# Metropolitan Planning Commission

Broadway Hotel Case # 8  
Supplement PDF

Staff Reports

**Zone Change 2006SP-183U-09**  
**Broadway Hotel: Amendment #1**  
**(formerly Westin)**

Sky Exposure Plane of the proposal (left) and adopted SP plan (right), with height labeled

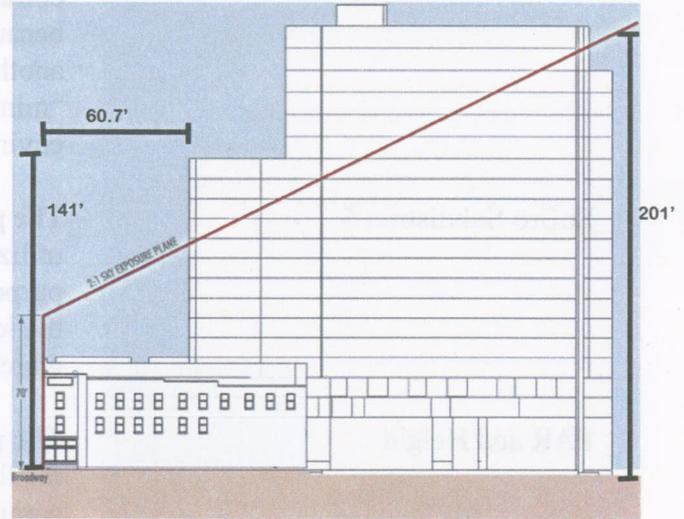
In addition, the Second and Broadway DNDP limits development to a 2:1 sky exposure plane. This sky exposure plane is intended to limit the impact of new development on the Broadway Historic District. The placement of structures within this sky exposure plane

is consistent with the existing buildings on Broadway, which have historically been human-scaled, ranging from two to five stories. Below is a diagram of the sky exposure plane applied to the adopted SP plan and proposed SP plan. As demonstrated, the tower is taller in the portion of the building closest to Broadway.

The boundary of the proposed SP amendment remains the same as the adopted SP plan. The site includes everything between Broadway, 2nd Avenue South, 3rd Avenue South, and the Shelby Street Bridge, with the exception of two properties. The plan calls for a maximum of 475 hotel rooms and associated retail and restaurant uses. The adopted SP plan is approved for 375 hotel rooms and 48 condominiums. The retail and restaurant uses are oriented to pedestrian activity on Broadway. The restaurant is within the rehabilitated historic buildings, along with a small number of hotel rooms. The remainder of the hotel rooms are within the tower. The base of the building is three stories and the tower, which is setback 60' from Broadway, is 16 stories, or 186 feet, at the highest point. The approved plan included base of three stories and a tower that was set back 60.7 feet from Broadway and was 19 stories, or 201 feet, at the highest point. The portion of the tower closest to Broadway is taller, at 157 feet, than in the approved plan, which was 141 feet. (See Sky Exposure Plane graphic above.)

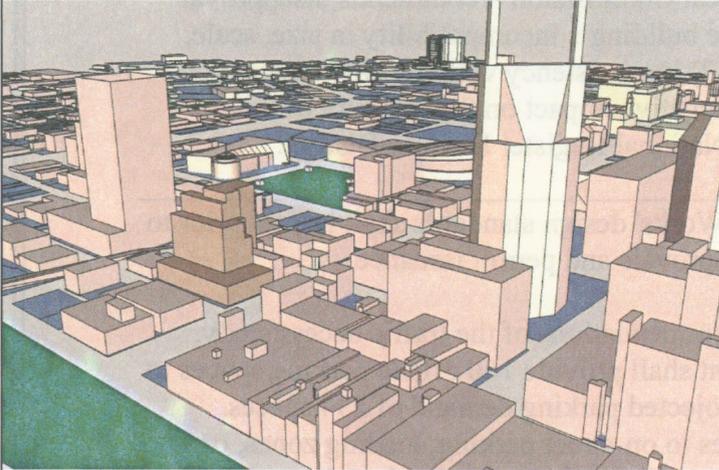
3. The adopted SP allows a 19 story building with a height of 201 feet, without rooftop mechanical and screening. The proposed SP would allow a 16 story building with a height of 186 feet. The SP includes a maximum height of 200 feet to account for rooftop mechanical and screening. Again, staff is not concerned with the height solely as a number. Staff is more concerned about the relationship of the tower to the Broadway Historic District. It would be possible to have a tower that was slightly taller than 16 stories, that was also more appropriate in this location, if it removed some of the mass closest to Broadway. Along with architectural treatments, this could create a tower that appears to be part of SoBro, instead of a shadow over Lower Broadway.

Staff recognizes that there is an adopted SP on this property. However, the proposed plan increases in intensity and FAR without lessening the impact on Lower Broadway. The front portion of the tower is 60-feet from Broadway and is 13 stories tall. While the width of this portion of the tower is approximately one-quarter of the frontage of the property, the position and design of the tower causes it to be interpreted by a pedestrian as a much larger mass. Staff would be

supportive of a design that lessened the impact to the Broadway Historic District, even if the plan technically increased FAR or possibly even the height at the rear of the site, away from Broadway.

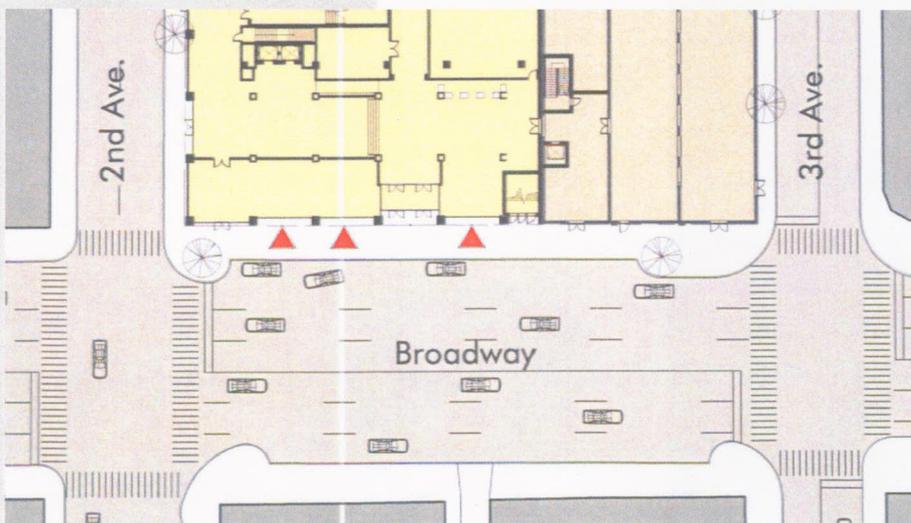
Staff evaluated the proposed SP amendment against both the Downtown Plan and the SP plan adopted by Metro Council. This request continues to be inconsistent with the Downtown Plan. While this request is better in some respects than the adopted SP plan, staff has determined that this request does not lessen the impact to Lower Broadway, due to a portion of the tower that is located closer to the Broadway Historic District. Staff recommends approval with conditions that will lessen the impact on Lower Broadway.

1. The Broadway street façade shall be pulled up to the property line with recesses and step-backs along the building edge only for entrance and design transition from old-buildings-to-new purposes. The street elevation of the new structure shall be in the same plane as the original 'historic' facades, in order to be consistent with other buildings in the historic streetscape. Although similar in form and materials, the composition and details of the new façade are to be more simplified. The design transition from old-buildings-to-new shall be reinforced by the narrow recessed connector.
